PROJECT DEFINITION REVIEW

A. US Route 5/Sykes Mountain Avenue Roundabout

B. Sykes Mountain Avenue/Ralph Lehman Road Roundabout

FIGURE 2--SPEED ANALYSIS US ROUTE 5/SYKES MOUNTAIN AVENUE CONCEPTUAL LAYOUT

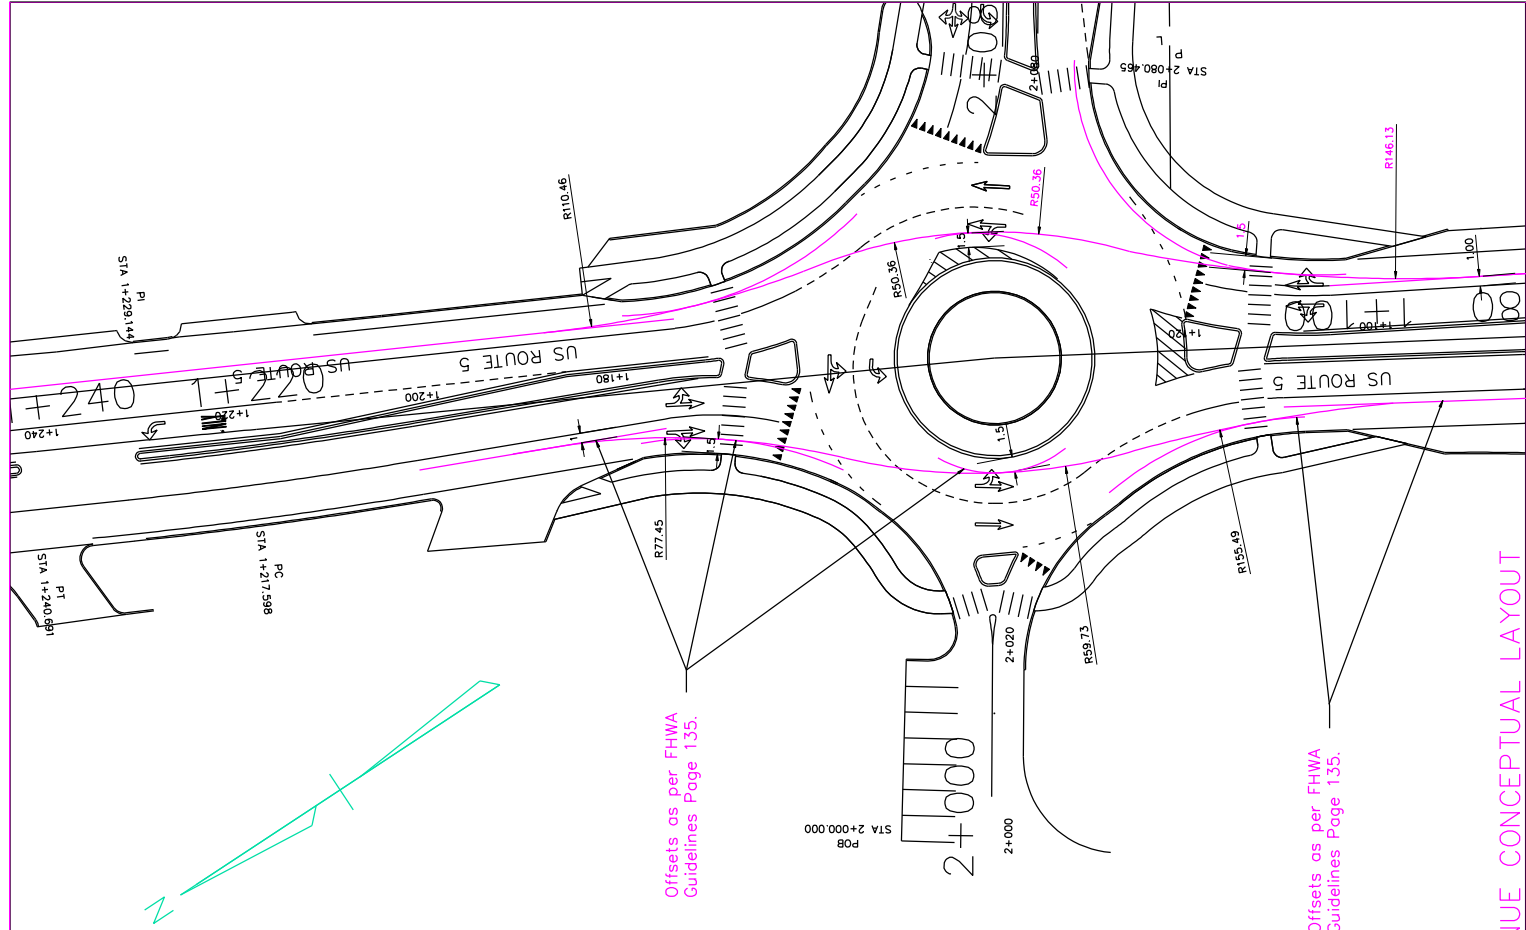
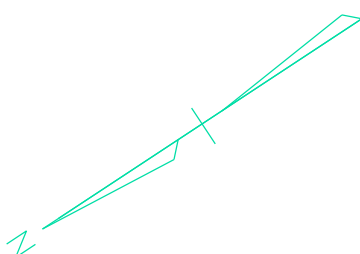
The layout shown in the Conceptual Plans allows speeds significantly greater than the proposed design speed (See Figure 2). Higher speeds in roundabouts have been shown to have higher crash rates. As was shown in Figure 1, these higher speeds also have a significant impact on the safety of pedestrians at the intersection. The current geometry will also allow a significant speed differential between the circulating vehicles (vehicles going at least three-quarters of the way around the roundabout) and the vehicles passing through or taking a right turn. Roundabout locations with a

Northbound

Estimated enter speed 146m is approximately 60 km/h = 37 mph

Estimated R2 Speed 50m radius is 37 km/h = 23 mph

Estimated R3 exit speed 110m is approximately 48 km/h = 30 mph

Southbound

Estimated enter speed 77.45m is 42 km/h = 26mph

Estimated R2 Speed 59.73m radius is 39 km/h = 24mph

Estimated R3 exit speed 155.49m is approximately 65km/h = 40mph

FHWA Guidelines Recommends Maximum Entry Speed R1 of 40 kmp/h 25 mph that R1 should be less than R2 and R1 should be smaller than R3. R1, R2 and R3 should be similar if pedestrians are present.

significant differential in speeds usually result in high numbers of crashes and injury crashes.

To modify the proposed two-lane roundabout to comply with the FHWA requirements for speed and deflection while still accommodating WB-67 trucks on all movements means that the roundabout would need to be much larger. Both the center island and the inscribed circle diameters would need to be increased. This would require an increase in the required right-of-way.

To mitigate some of the need for additional right-of-way, we recommend the use of a single-lane roundabout with turning lanes. The difference between this design and the two-lane roundabout is that there would only be a single lane exiting the roundabout for both northbound and southbound US Route 5. This design provides a roundabout that meets the projected traffic volumes while minimizing safety concerns (See Figure 3).

FIGURE 3-US ROUTE 5/SYKES MT AVENUE RECOMMENDED DESIGN

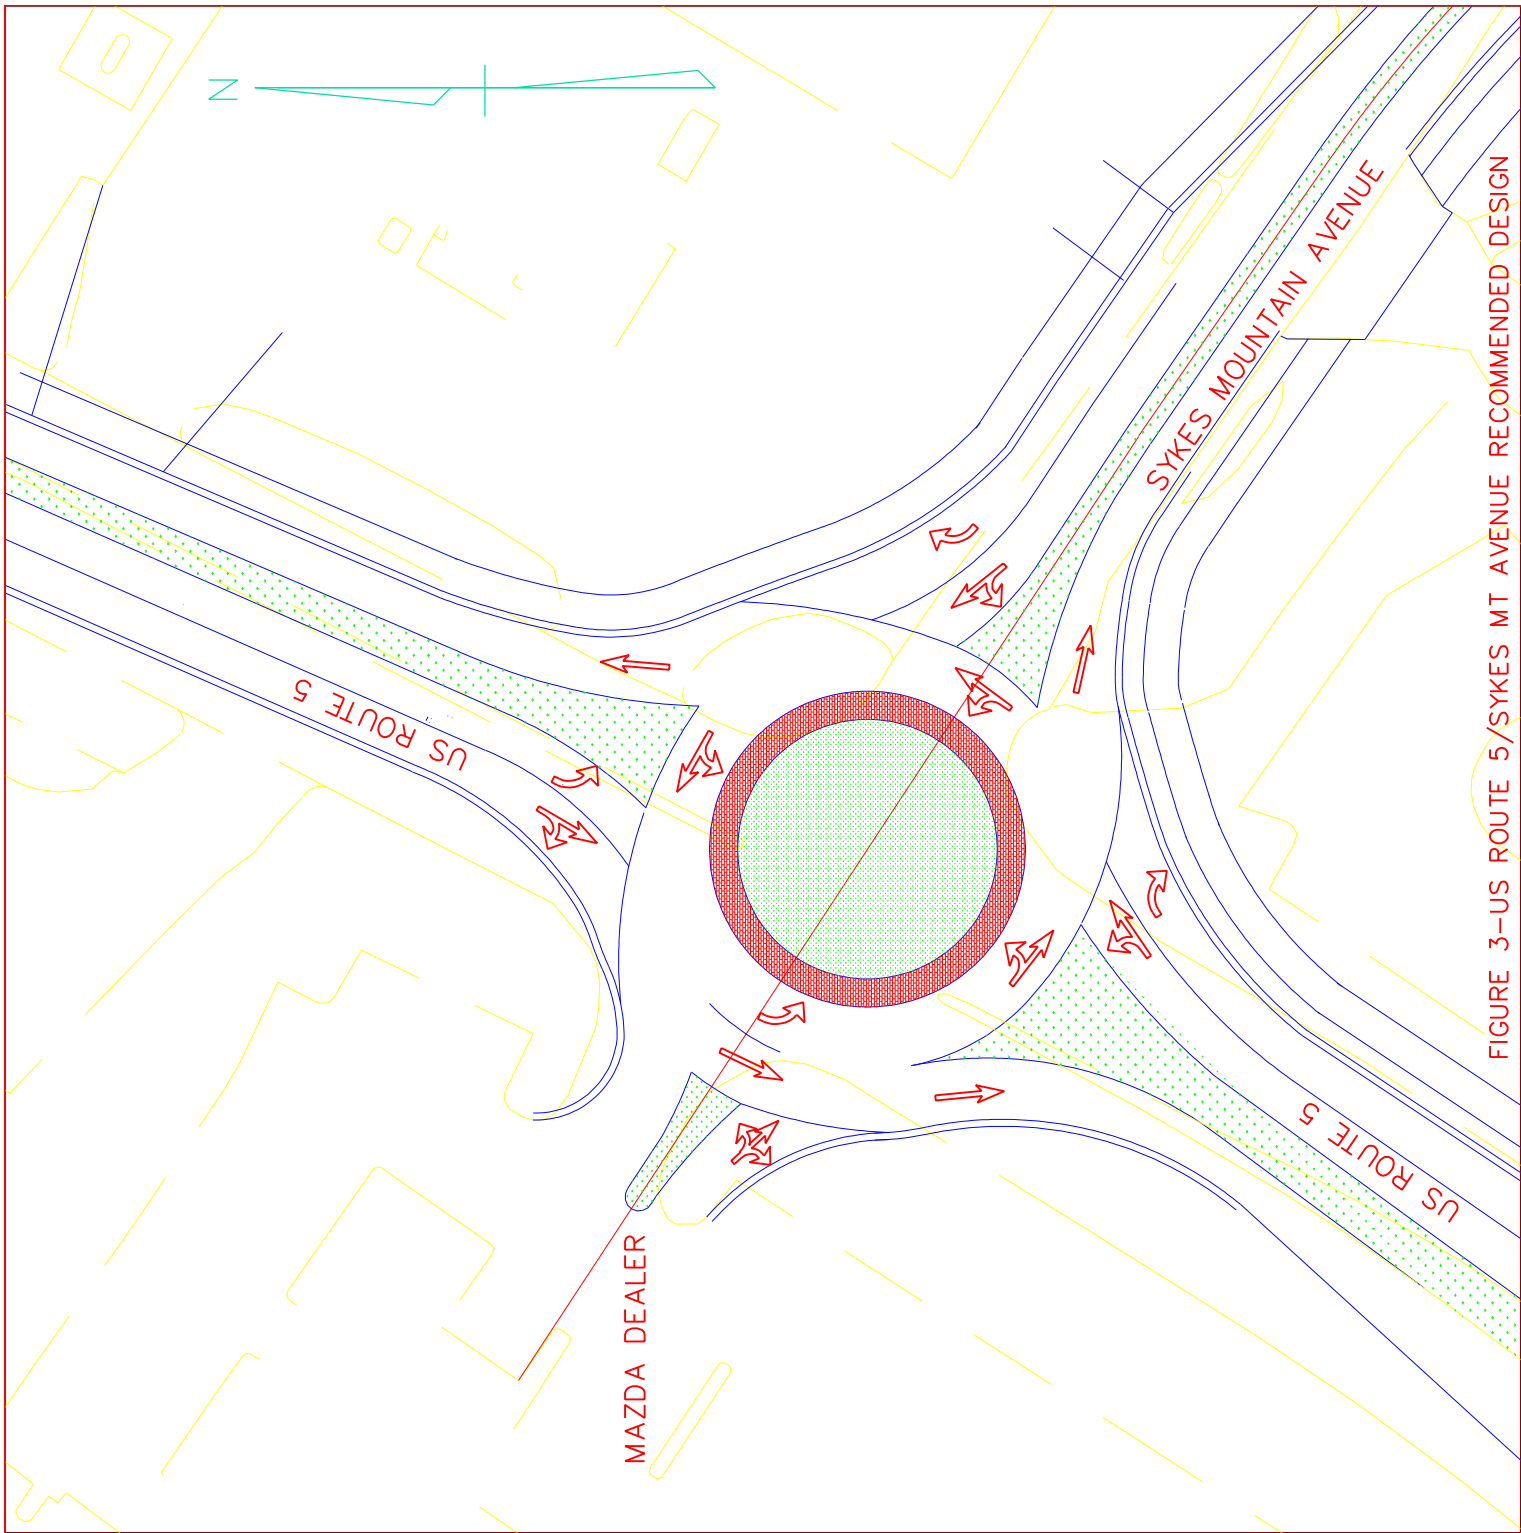
The advantages of this alternative design, which provides the required capacity through the design year, as opposed to the current layout are:

- Lower Projected Crash Rate
- Lower Construct Cost
- Safer for Pedestrians
- Less Property Impacts/Lower ROW costs

FIGURE 4--SPEED ANALYSIS SYKES MOUNTAIN AVENUE/RALPH LEHMAN ROAD CONCEPTUAL LAYOUT

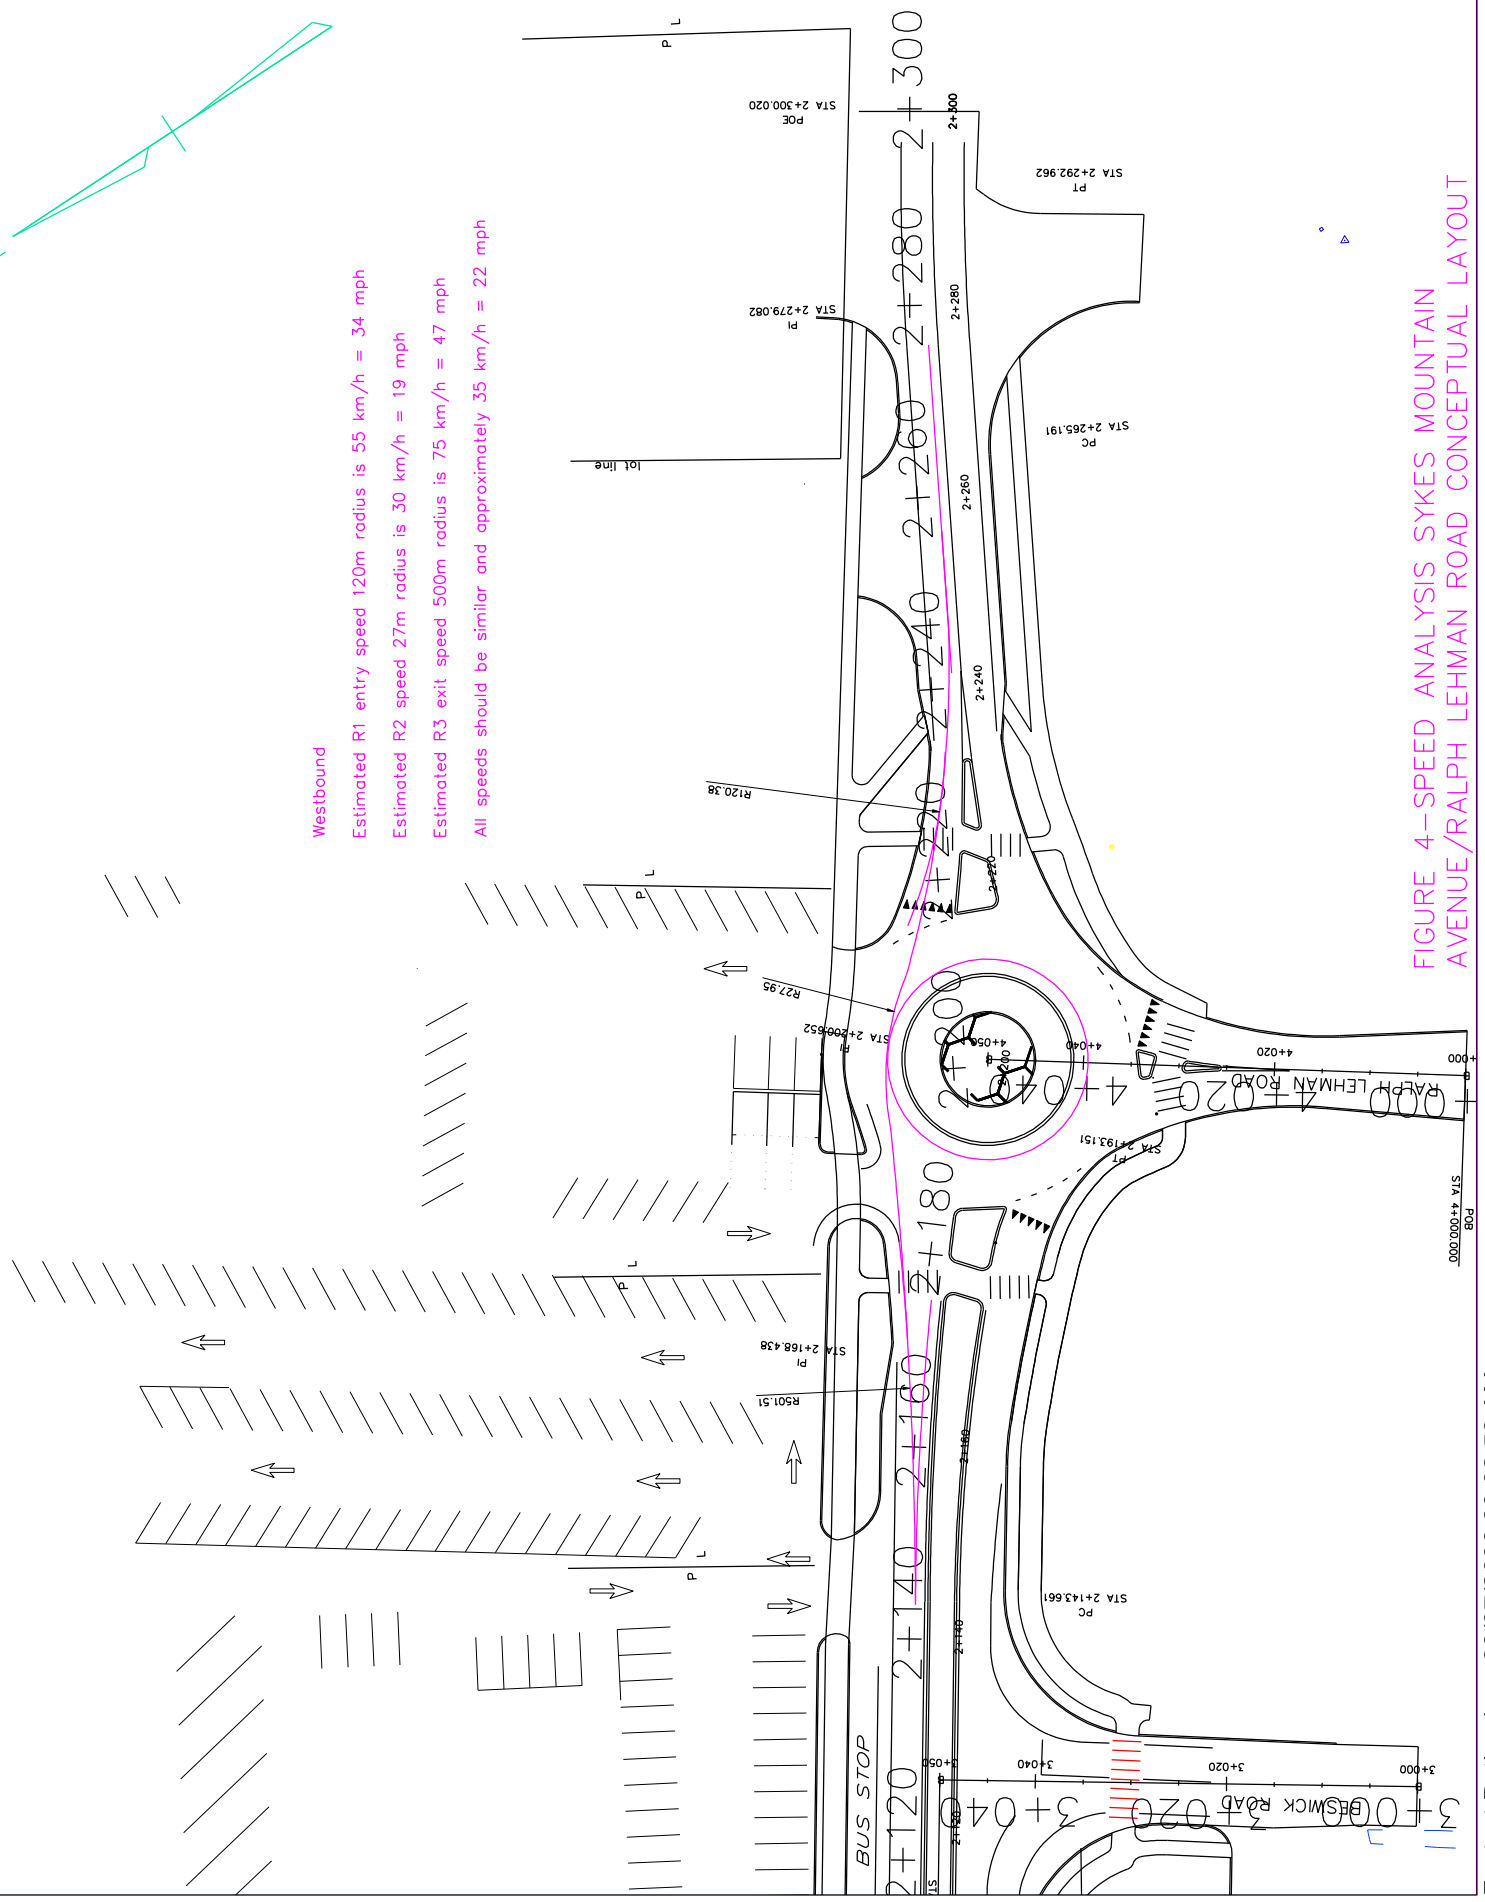
The FHWA document, Roundabouts: An Informational Guide, recommends a design speed of only 15 mph for mini-roundabouts. It is simply not possible to design a mini-roundabout for a design speed of 15 mph that will accommodate WB-67 trucks (See Figure 4). When designing single lane roundabouts for WB-67 trucks, the central island must be enlarged to accommodate the enormous swept path of these trucks. To design a mini-roundabout at 15 mph would simply prohibit all larger vehicles except SU vehicles even making the through movement. To design a roundabout at 15 mph

Westbound

Estimated R1 entry speed 120m radius is 55 km/h = 34 mph

Estimated R2 speed 27m radius is 30 km/h = 19 mph

Estimated R3 exit speed 500m radius is 75 km/h = 47 mph

All speeds should be similar and approximately 35 km/h = 22 mph

to comply with the FHWA Guidelines requires the use of very small radii and very narrow lanes that would not be compatible with a larger truck. The swept paths on the entry to a roundabout for a WB-67 truck are typically 22 to 30 feet depending on the diameter of the roundabout. This very wide swept path also substantially increases the speed through the roundabout and requires special design treatments even in a larger roundabout to achieve a design speed equal to 25 MPH per the FHWA recommendations.

Because of the poor crash history on arterial roads, the need to design to 15 mph, and the inability to provide sufficient visibility in all weather conditions, the use of a mini-roundabout at this intersection is not recommended. Our recommendation is to design this intersection as a single lane roundabout with a raised central island and truck apron (See Figure 5). Per FHWA standards, the design speed for the single-lane roundabout should be approximately 20-25 mph.

FIGURE 5--SYKES MT AVENUE/RALPH LEHMAN ROAD RECOMMENDED DESIGN

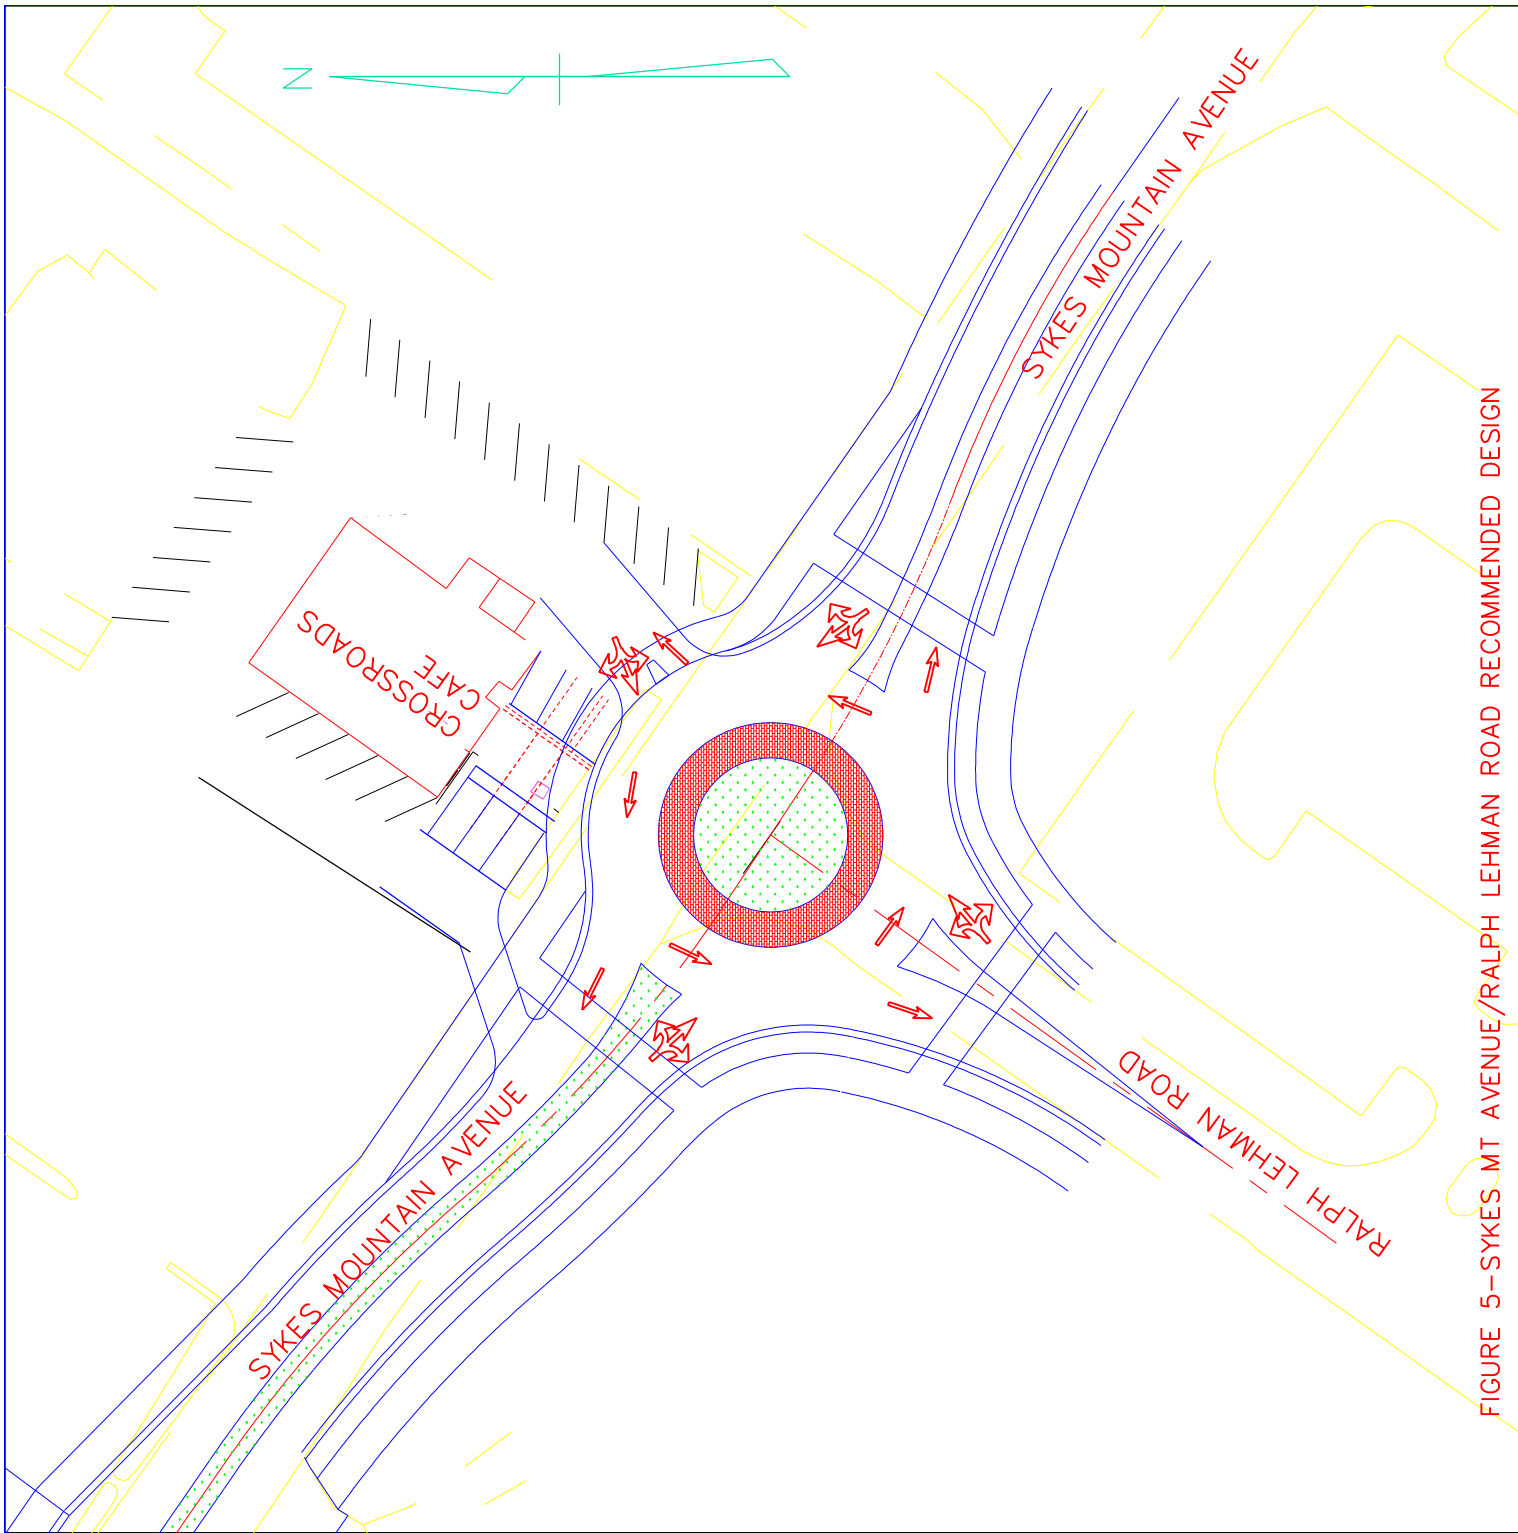
The roundabout at Ralph Lehman Road should allow vehicles traveling eastbound on Sykes Mountain Avenue to reverse directions in order to access businesses on the north side of the road. The roundabout should also allow vehicles turning onto Sykes Mountain Avenue from Beswick Road or Ralph Lehman Road to reverse direction and access US Route 5. We have not been able to locate a single user within these areas that has deliveries from a vehicle larger than a WB-50 (See Appendix B). Traffic to the Comfort Inn could have vehicle traffic of varying sizes, but note that a WB-67 is a tractor that includes a sleeping compartment. To design the roundabout to completely circulate a vehicle of that size requires a choice between compromising the safety of all the other users versus significant right-of-way impacts. We recommend that the roundabout be designed for full access for a WB-50, while allowing a WB-67 to pass through the intersection along Sykes Mountain Avenue.

In Figure 4 we have provided a proposed roundabout that meets the FHWA requirements for design speed, visibility, and pedestrian safety and is expected to provide the lowest crash rate for any form of traffic control for this intersection. This roundabout is designed for a WB-50 truck to make all movements. WB-67 trucks can proceed through the roundabout along Sykes Avenue with the addition of truck aprons at the entry lanes. Once the design vehicle and type of roundabout have been decided, final impacts to the adjacent properties, access points, landscaping, and bicycle and pedestrian facilities can be finalized.
